MILK FARM PROJECT

FINAL ENVIRONMENTAL IMPACT REPORT

September 2005

Responses to Comments

Figure 4.8-A

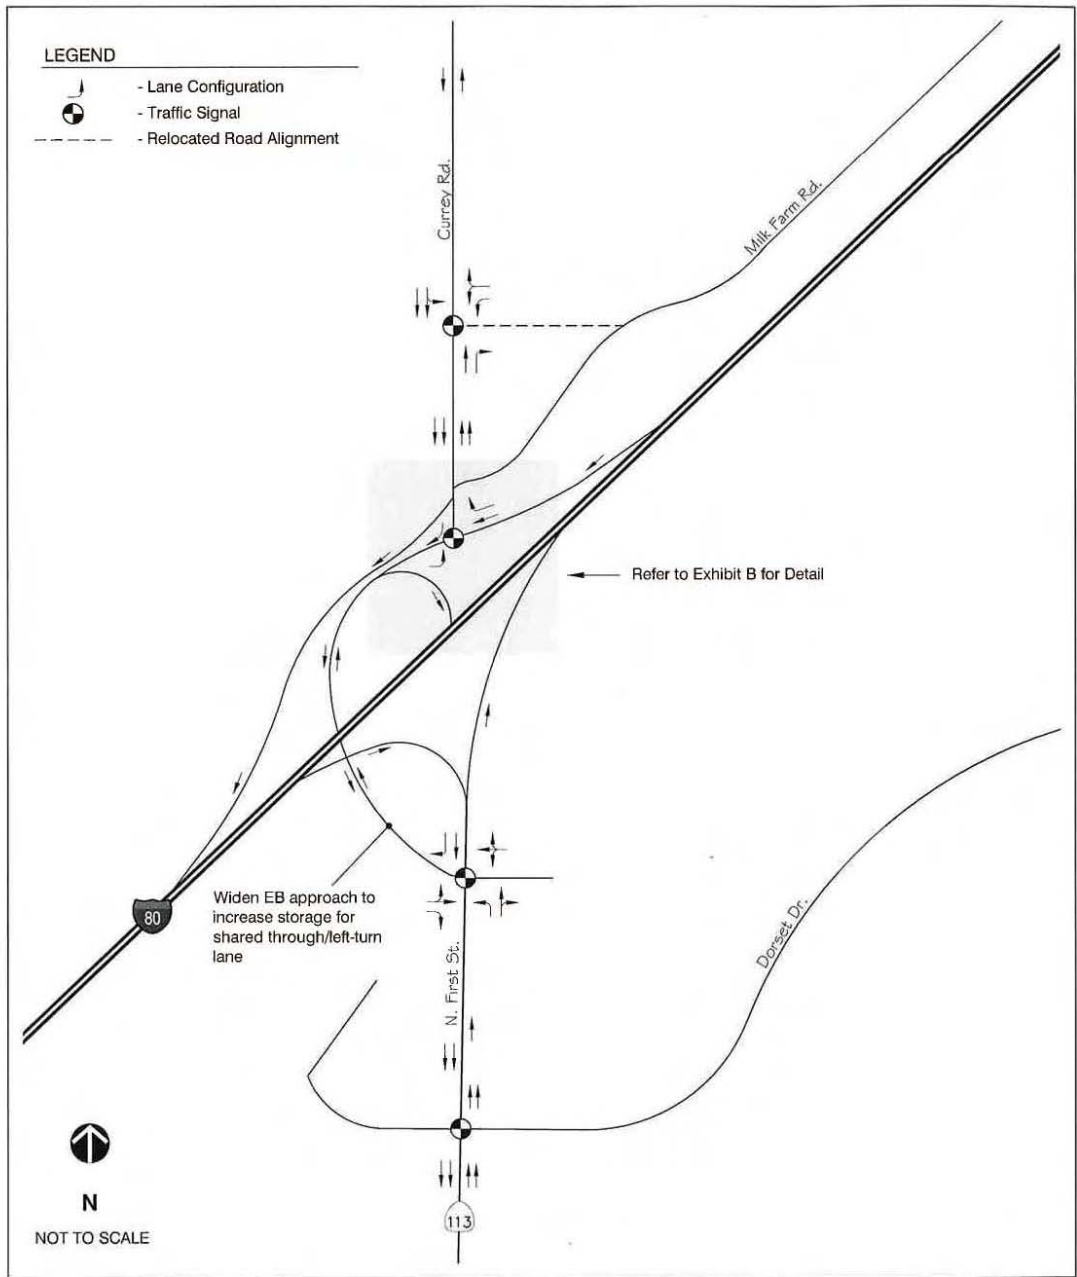
Please modify Anticipated Future Mitigation Measure 4.8-2 to identify that the conceptual land use plan may not allow for expansion of the North First Street/I-80 interchange, which is identified in the I-80/I-680/I-780 Major Investment & Corridor Study, July 14, 2004 (prepared by Korve Engineering for the Solano Transportation Authority).

Mitigation Measure 4.8-2 on page 4.8-29 has been modified to address the potential need for increased spacing between the Interstate 80 westbound ramp intersections and Milk Farm Road and to provide additional discussion of the improvements at the Currey Road/Milk Farm Road intersection, as follows:

Prior to site development, the applicant shall realign Milk Farm Road (north of its current location), install a traffic signal, and provide ~~a separate left-turn lane and a shared left-/right-turn lane on the westbound approach~~ the following lane configurations:

These lane configurations will require the widening of the southbound approach to two lanes in advance of the intersection and will require widening Currey Road (from one to two lanes in each direction) between the realigned Milk Farm Road and the Interstate 80 westbound ramps intersection. Figure 4.8-A shows the recommended improvements.

Intersection spacing between the Interstate 80 westbound ramps intersection and Milk Farm Road should be coordinated with the City of Dixon Engineering Department, which may require spacing greater than that shown on the conceptual site plan for the Milk Farm project and modification of the site plan land uses to accommodate the preliminary interchange configuration identified in the Interstate 80/Interstate 680/Interstate 780 Major Investment & Corridor Study, July 14, 2004 (prepared by Korve Engineering for the Solano Transportation Authority). Installation of a traffic signal would be warranted based on weekday PM peak hour traffic volumes under existing plus project conditions.
